From: Watkins, Robert
Sent: Wednesday, September 18, 2019 2:15 PM
To: 'lcoile@glaveandholmes.com'
Cc: Werner, Jeffrey B
Subject: September BAR Action - 1824 University Circle

BAR 19-09-02

1824 University Circle, Tax Parcel 060097000

Modifications to Pergola

Brody Jewish Center, 1824 University Circle — Rear Terrace Pergola

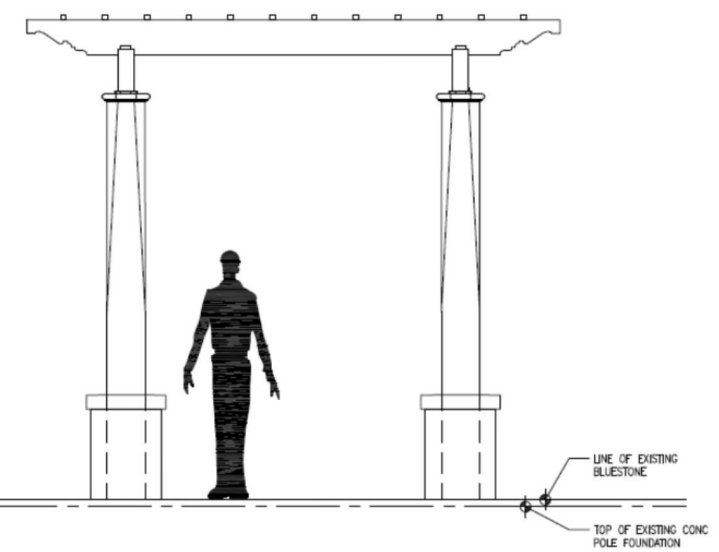
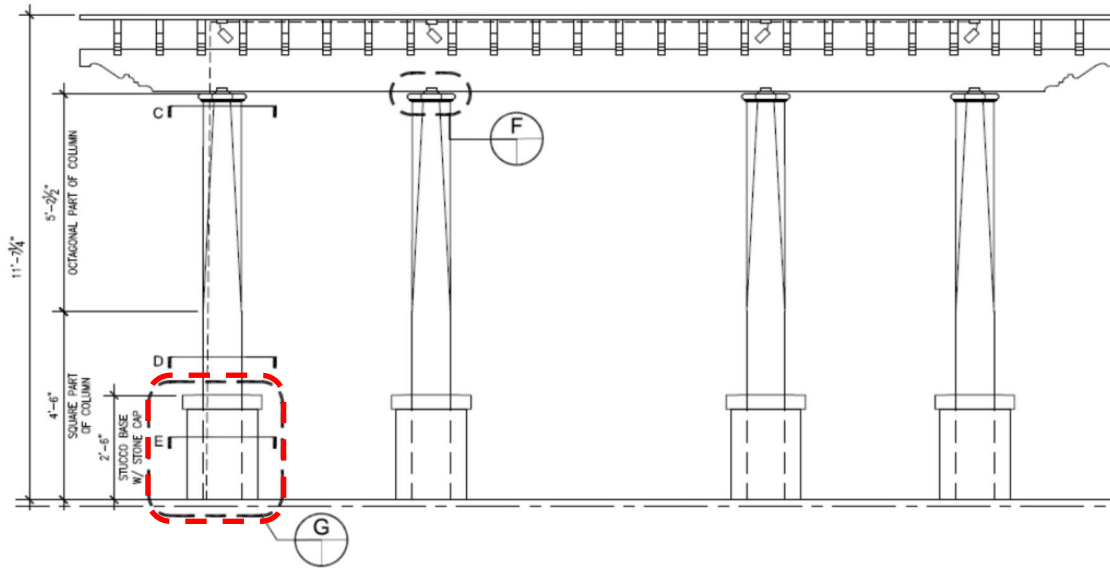
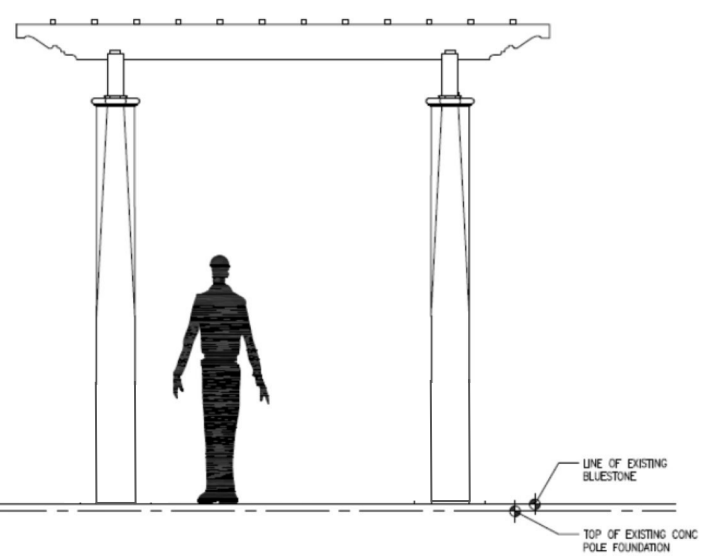
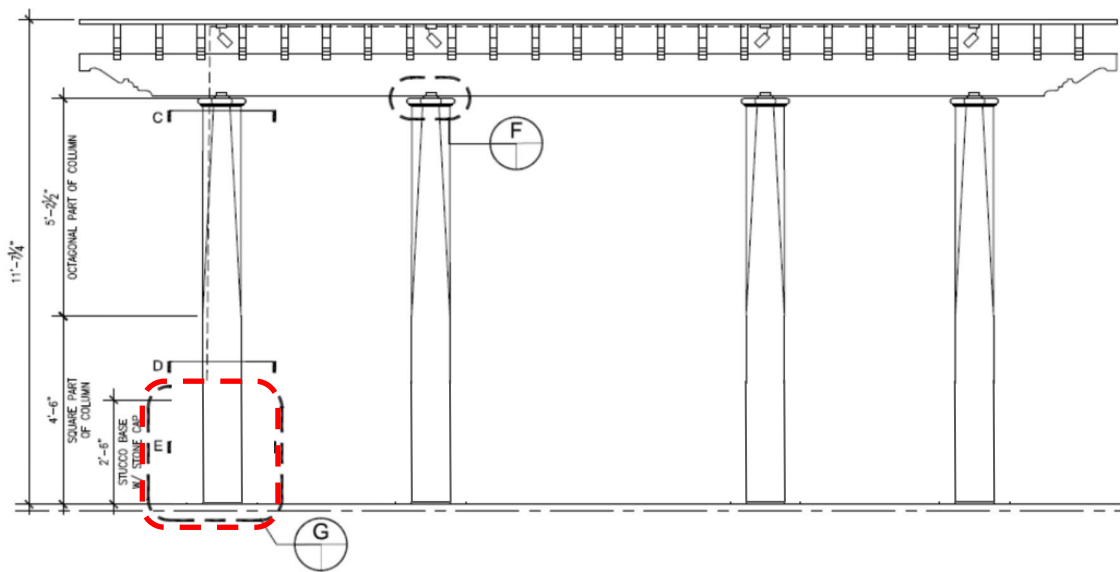
Omit the previously approved stone and stucco bases to the square pergola posts. The square post profiles continue to the pavers. No changes are proposed to the approved purlins and rafters.

The pergola is a new element at the site. The original design reflected the existing Doric columns on the building, however the proposed changes are not incompatible with the design and scale of the existing structure. Staff recommends approval.

Revised posts with stone/stucco bases - BAR approval July 16, 2019

Proposed revision: omit stone/stucco bases - August 5, 2019
